VARIANCE / FIELD CHANGE NOTICE	Significant? (Yes or No): YES	V/F: 21130-PSP-0001-1
WBS NO.: PROJECT/DOCUMENT/ECDC # 21130-PSP-0001 Rev.0		Page: 1 of 1
PROJECT TITLE: Project Specific Plan for Area 9, Phase II Precertification Real-Time Scan		Date: 2/13/03

FIGURE 1. A9PII EAST OF A1PII PRECERTIFICATION
PHYSICAL SAMPLE LOCATIONS

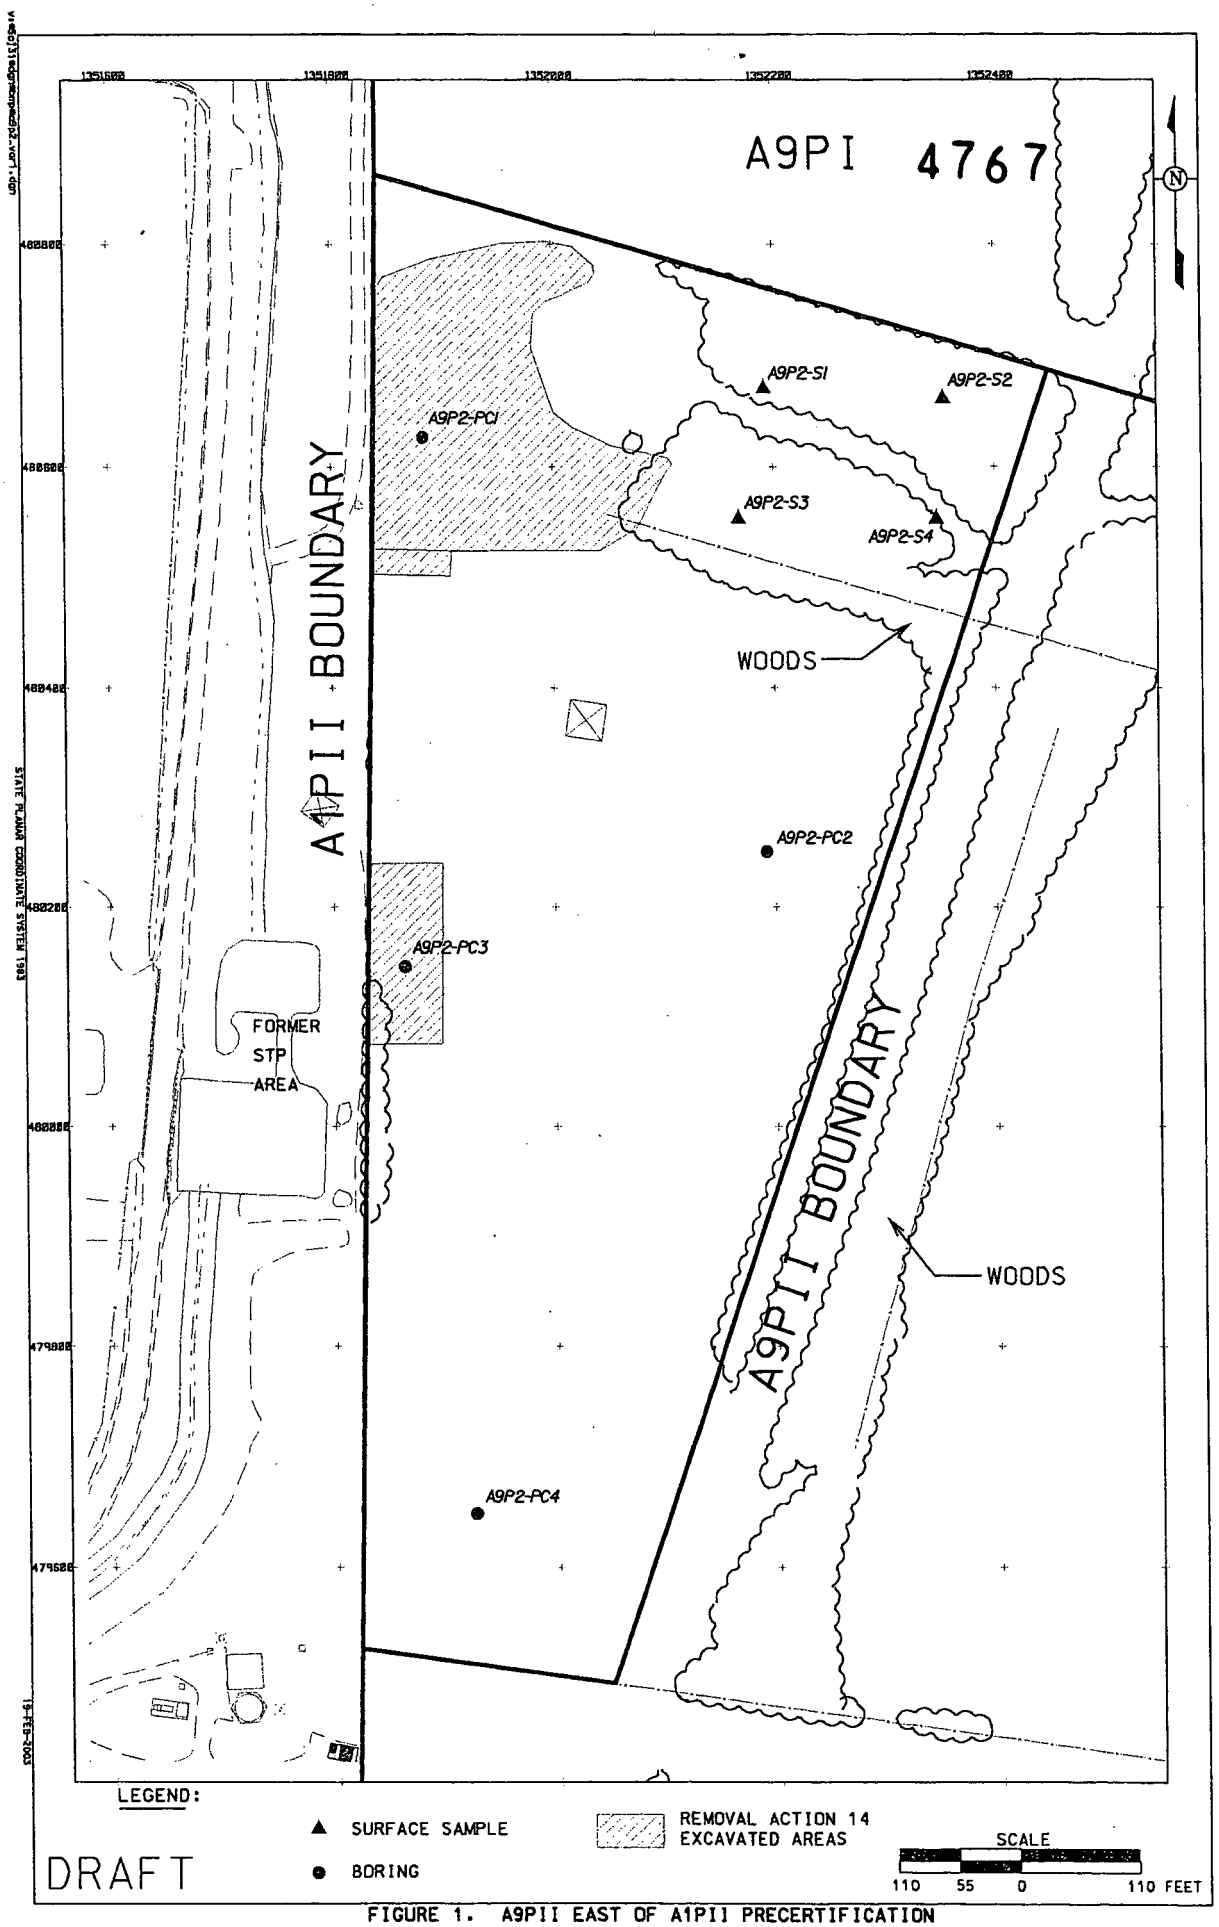
This Variance/Field Change Notice (V/FCN) documents the collection of physical samples in Area 9, Phase II (A9PII) located off-property east of the Fernald Closure Project.

Four (4) surface samples will be collected in the uncultivated, wooded portion of A9PII. The samples will be collected to a depth of 6-inches. These samples will be analyzed for total uranium (TAL B) at the onsite laboratory and submitted to an offsite laboratory for dioxin/furan (TAL G) analysis.

Four (4) borings will be collected in the cultivated portion of A9PII. The borings will be extended to a depth of 36-inches and samples will be collected at every 6-inch interval (0 to 6-inch, 6 to 12-inch, 12 to 18-inch, etc.). Samples will be submitted to the onsite laboratory for total uranium (TAL B) analysis. Samples will also be submitted to an offsite laboratory for radiological (TAL C), metals (TAL D), PCB (TAL E), and VOC (TAL F) analysis.

All samples collected under this V/FCN are identified on Attachment 3 and the locations are shown on Figure 1.

Per section 3.4.8 of the SEP Addendum, subsurface soil sampling will be conducted to determine representative concentration profiles of COCs to atleast a 2-foot depth below the cultivated depth.

Physical samples will also be collected in the wooded portion of A9PII since weather has impacted the use of real-time monitoring equipment in this area. Physical sampling will not be used in place of real-time monitoring.
